HISTORIC PRESERVATION COMMISSION

MEMORANDUM

SUBJECT: Historic Area Work Permit # 1128193 - Fenestration Alterations

7319 WILLOW AVE,
RENOVATION

Woodwright Double-Hung Full-Frame Windows

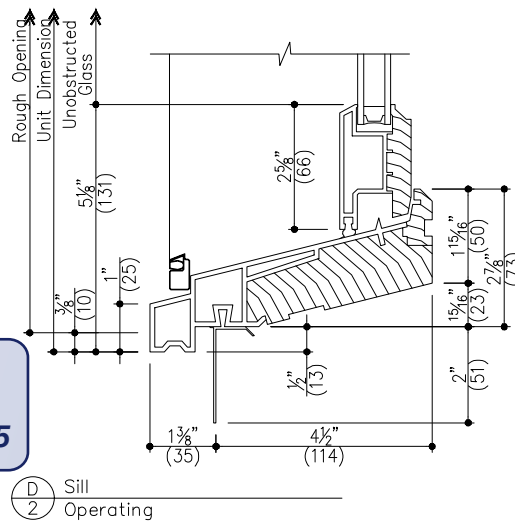
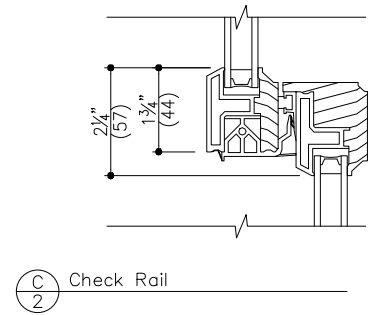
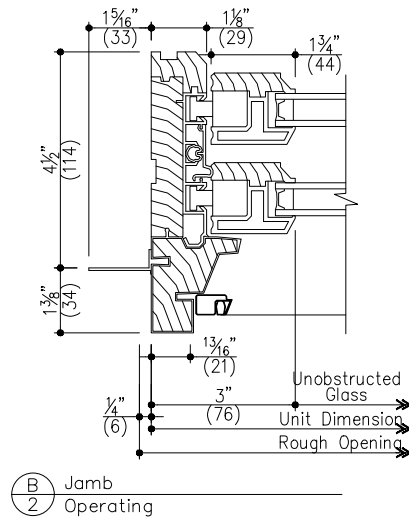
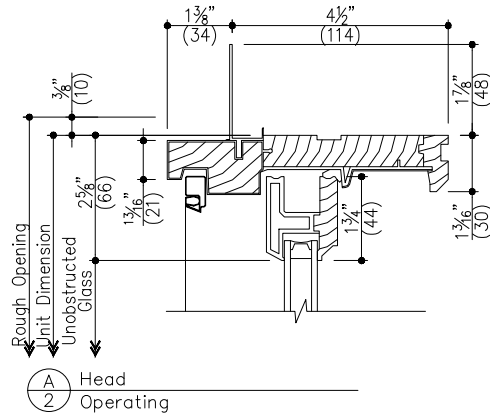
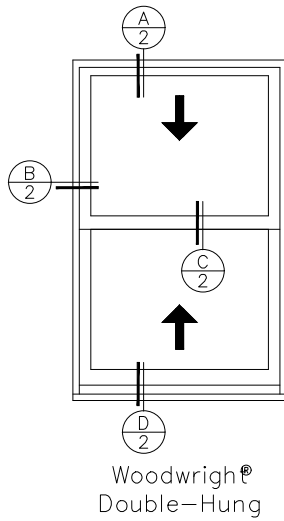
1. Measured drawings, including profiles, of the proposed window need to be submitted to Staff before issuing the final HAWP approval documents.

The HPC staff has reviewed and stamped the attached submission materials and has determined the condition has been satisfied.
